HISTORIC AND DESIGN REVIEW COMMISSION

December 05, 2018

HDRC CASE NO: 2018-596
ADDRESS: 637 N MAIN AVE
LEGAL DESCRIPTION: NCB 788 BLK 2 LOT 10 FOX TECH HIGH SCHOOL
ZONING: D,HS
CITY COUNCIL DIST.: 1
LANDMARK: SA High School
APPLICANT: RVK Architects
OWNER: San Antonio ISD
TYPE OF WORK: Site and parking modifications, ROW improvements
APPLICATION RECEIVED: November 16, 2018
60-DAY REVIEW: January 15, 2018
REQUEST:

The applicant is requesting a Certificate of Appropriateness for approval to:

AS-101
OVERALL SITE PLAN

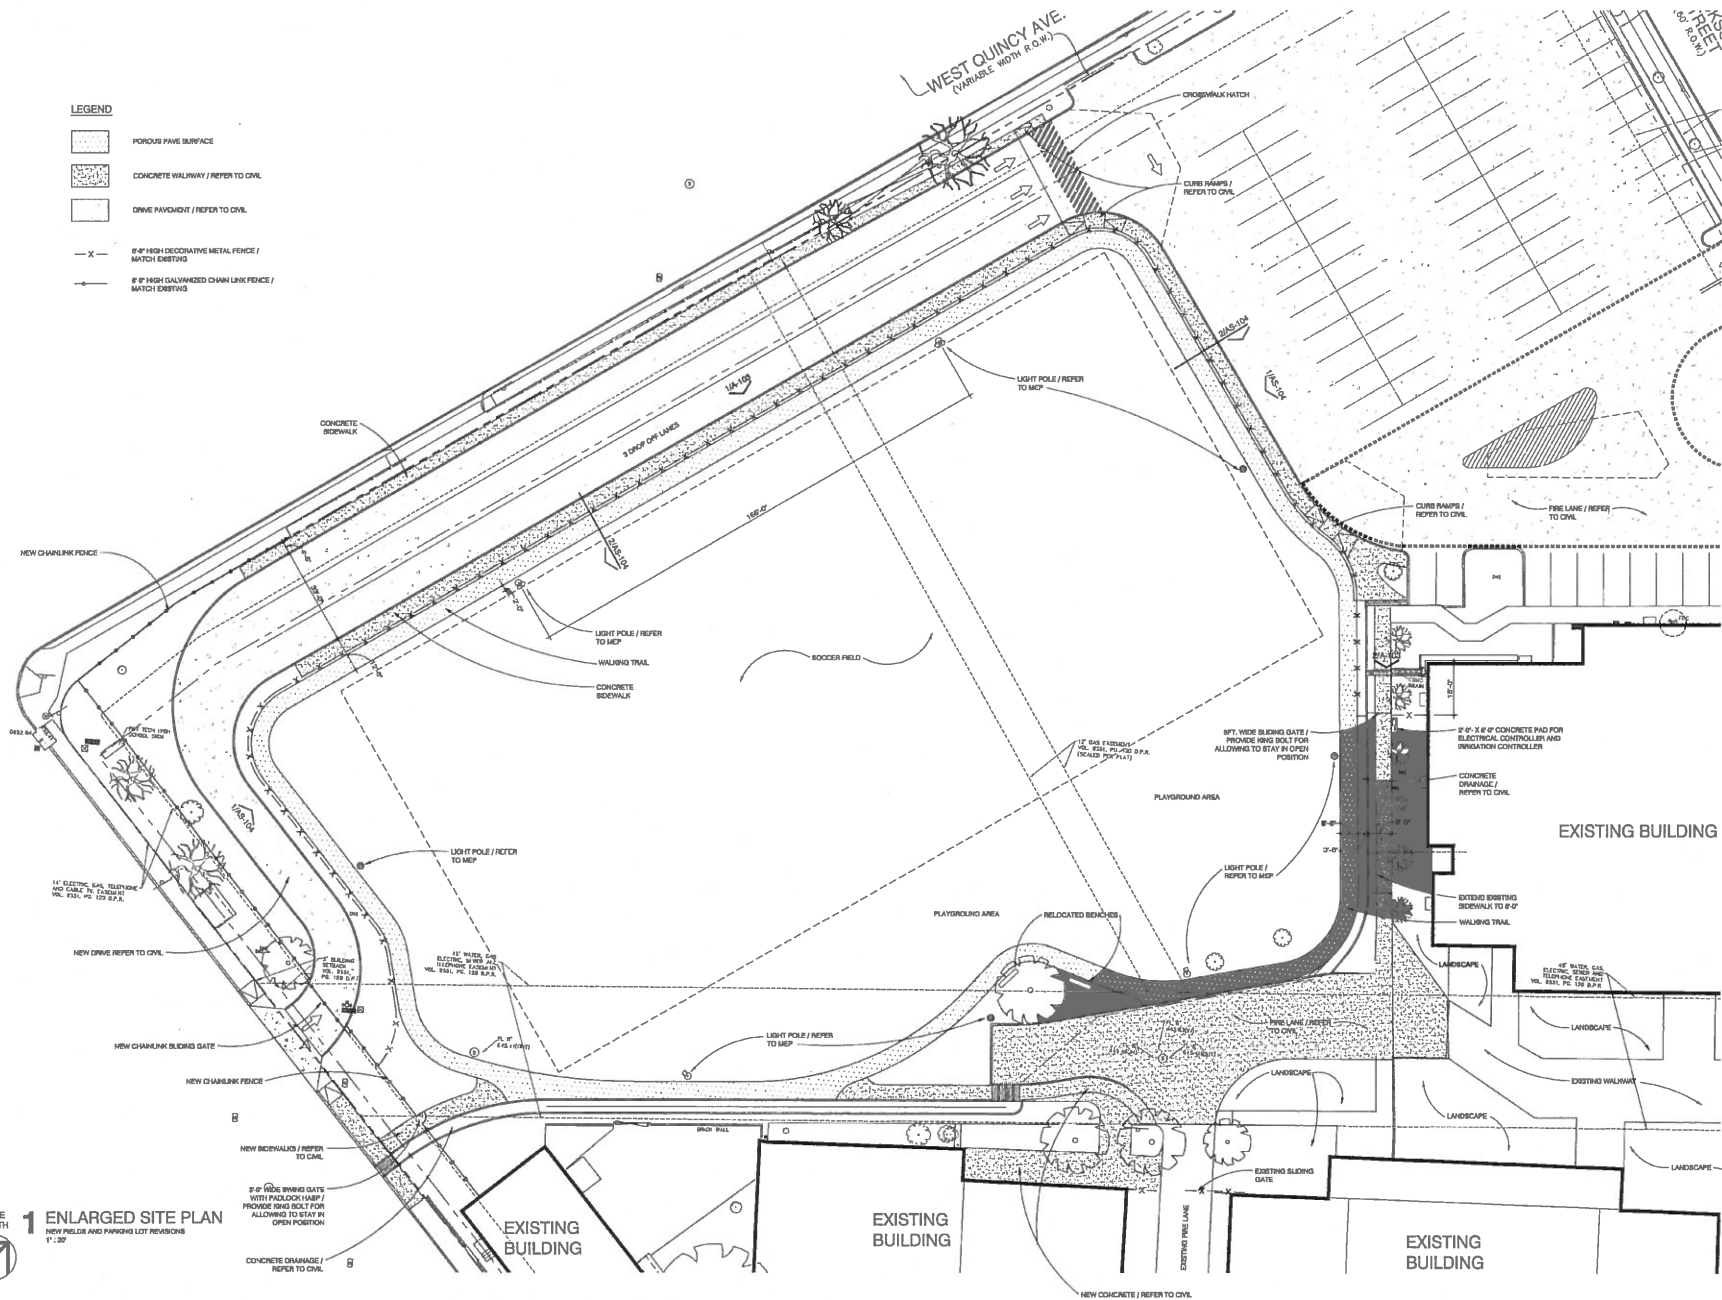
- c. **QUEUING LANES AND WALKWAYS** – The applicant has proposed to install new queuing lanes and walkways along the W Quincy right-of-way. The lanes will be located within the property boundary, partially located in the area of the existing baseball diamond. Staff finds that the modifications will not adversely affect

- d. **PEDESTRIAN WALKWAYS** – The applicant has proposed to install a sidewalk fronting the N Flores right-of-way to connect to an existing bus stop. The applicant has also proposed to install pedestrian access from N Flores to the interior of the site per the submitted site plan. Staff finds the proposal consistent.

- e. **CANOPY** – The applicant has proposed an open air canopy structure to cover a pedestrian walkway at the frontage of the bend where Jackson St becomes Romana St, as indicated in the submitted site plans. The structure will be constructed of clear anodized columns and beams, white roofing and fascia. Staff finds the proposed design, materiality, and location appropriate for the site.

Staff recommends approval based on findings a through f with the following stipulations:
